*Public works* DEPARTMENT.

*Proceedings of the Madras Government, Public Works Department,  
7th November 1862.*

No. 166. Read the following letter from Lieutenant-Colonel J. OUCHTERLONY, R. E., Deputy Chief Engineer, Southern Circle, to Colonel W. I. BIRDWOOD, R. E., Secretary to Government, Public Works Department, dated Ootacamund, 16th October 1862, No. 110.

No. 168. ORDER THEREON, 7th November 1862, No. 2,689.

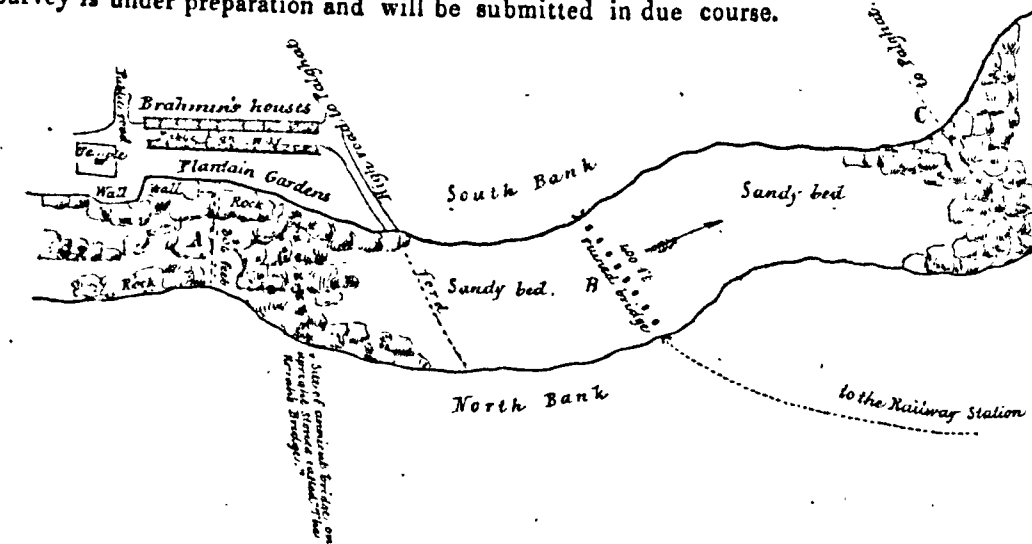
3. By far the best site† for a bridge however exists at a point higher up the stream, nearly opposite a Brabmin temple and a street of Brahmins' houses; and the only reason that I can find assigned for its not having been selected originally is that powerful interest was brought to bear to prevent a public highway being brought within contaminating distance of their (assumed) sacred precincts. Its position will be understood by the subjoined rough sketch; but a proper survey is under preparation and will be submitted in due course.

The description of bridge which I would recommend for construction here is one on rows of wrought iron piles, the butts of which I propose to let into deep sockets cut in the solid rock, which forms the bed of the river from bank to bank at the point indicated, and to secure them by leading. The platform to be carried on solid girders, of plate iron for the larger central span, and of timber for the minor bays.

8. I have next to remark upon the site proposed for the new bridge (*A* in sketch to paragraph 3), which has but one objection. This is the necessity which its adoption will involve of forming the southern approach through land, and even through a row of houses, occupied by Brahmins of Kulputty, by whom I am informed the most strenuous opposition will be exhibited. Government will probably remit this question for the consideration of the Board of Revenue and of the Collector of the District, and I will therefore merely add that the construction of a bridge at *A* will not necessitate the invasion by a single foot of the (so called) sacred precincts of the Brahmins; the temple and its enclosing wall being entirely avoided.

9. In the event however of Government deciding to reject the site *A*, I have to represent that the spot next to it in eligibility for a viaduct, occurs at a point 7 or 800 yards lower down the river, marked *C* in the sketch, where the solid rock crops out completely across the bed, presenting only one broad channel to be spanned, 60 feet in width. The cost of a bridge however will be greater here than at *A*, both because the section is wider, and because there is a very considerable fall from *A* to *C* which will add greatly to the momentum of floating bodies, and hence necessitate extra strength in the iron work. And if the Brahmins are allowed to carry their point, I think they ought to be made to contribute whatever excess of cost may be established, as also the value of certain lands which will have to be taken up if the bridge is built at *C* to form a road from its southern approach to Palghát; (which I may remark will be a remarkably direct and useful one not above  $1\frac{1}{2}$  miles in length, leading straight into the main street of the Bazar).

1. Judging from the information furnished in the foregoing letters, the Government are of opinion that the site marked *A* in the sketch given at paragraph 3 of the first letter, is to be preferred, and they will, therefore, await the receipt of the necessary plan, estimate, &c., for a bridge at that place. In submitting those documents, the Government should be informed of the amount of compensation which will have to be paid for the land and the range of houses which it will be necessary to purchase\* for the formation

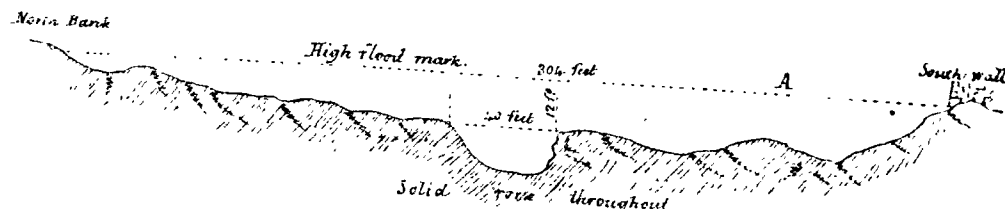
4. I annex a rough section of the river to show how remarkably favorable for such a structure the site *A* is. The river is, it will be seen, confined except during freshes to a deep channel in the solid rock which can be spanned by 40 feet girders; and the sockets for all the piles could be cut in dry rock at any period of the year except during the monsoon months, March, June, July and August.

I communicated with the stone cutters of Palghat and ascertained that sockets averaging 15 inches deep and 6½ inches square, can be cut in from four to five days, at a cost not exceeding Rupees 3 each. Teak-wood (of which there is a large quantity now lying available on the south bank of the river) can be obtained in good lengths at about Rupees 15 per "Candy" of 12½ cubic feet; and Erool wood, which would answer almost equally well, at half that price. The site is only 800 yards distant from the Railway Station, and hence the carriage of iron work and of all materials imported, would be easy and economical.

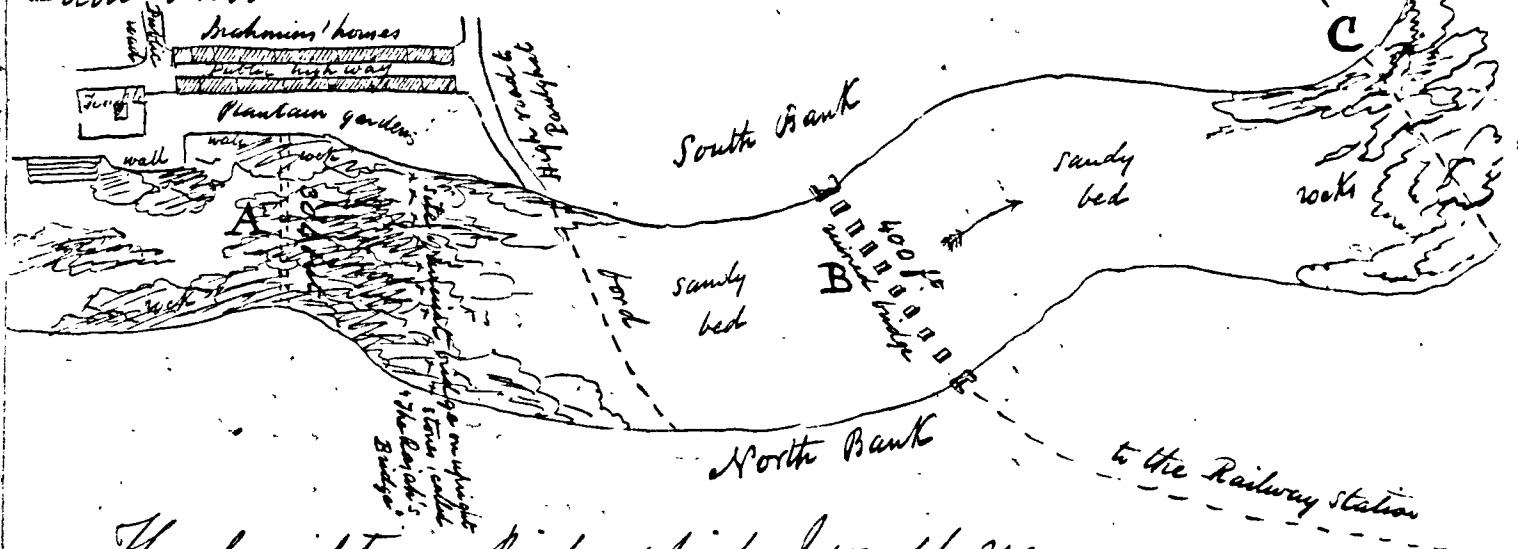
3. By far the best site\* for a bridge however exists at a point higher up the stream nearly opposite a Brahmin temple & street of Brahmins' houses; the only reason that I can find assigned for its not having been selected originally is that powerful interest was brought to bear to prevent a Public highway being brought within contaminating distance of their (assumed) sacred precincts.

Its position will be understood by the subjoined rough sketch; but a proper survey is under preparation, & will be submitted in due course.

The description of bridge which I would recommend for construction here is one on rows of wrought iron piles, the butts of which I propose to let into deep sockets cut in the solid rock, which forms the bed of the river from bank to bank at the point indicated, & to secure them by leading.

The platform to be carried on solid girders, of plate iron for the larger central span, & of timber for the minor bays.

Judging from the information furnished in the foregoing letters, the Govt. are of opinion that the site marked A in the sketch given at Para 3 of the first letter, is the proper place for the bridge, & they will, therefore, await the receipt of the necessary plans, estimate &c. for a bridge at that place. In submitting those documents, the Govt. should be informed of the amount of compensation which

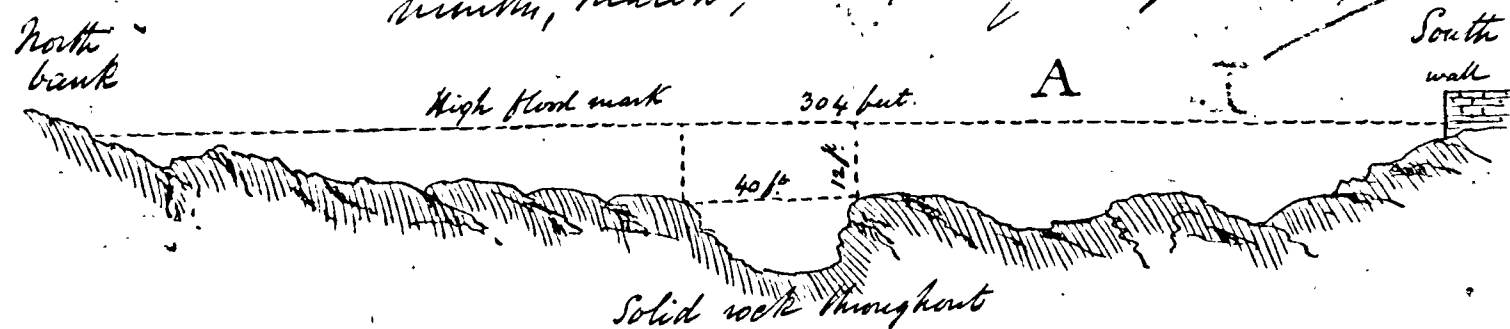
4. I annex a rough section of the river

to shew how remarkably favorable for such a structure the site A is. The river is, it will be seen, confined - except during freshets - to a deep channel in the solid rock which can be spanned by 40 feet girders; the sockets for all the piles could be cut in dry rock at any period of the year except during the monsoon months, March, June, July, August.

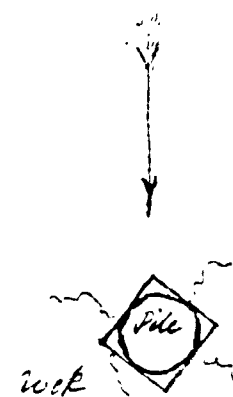
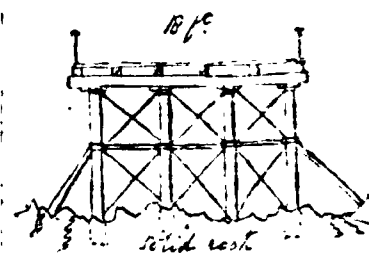
10. Should Govt. disapprove of my proposal to employ iron piles, a girder bridge might be built at C on masonry piers; but great solidity must be given to them, as the action of the streams & of floating trees must here be most violent. Subjoined is a rough section of the river's bed at C but a more correct one is under preparation, and will be submitted hereafter if required.
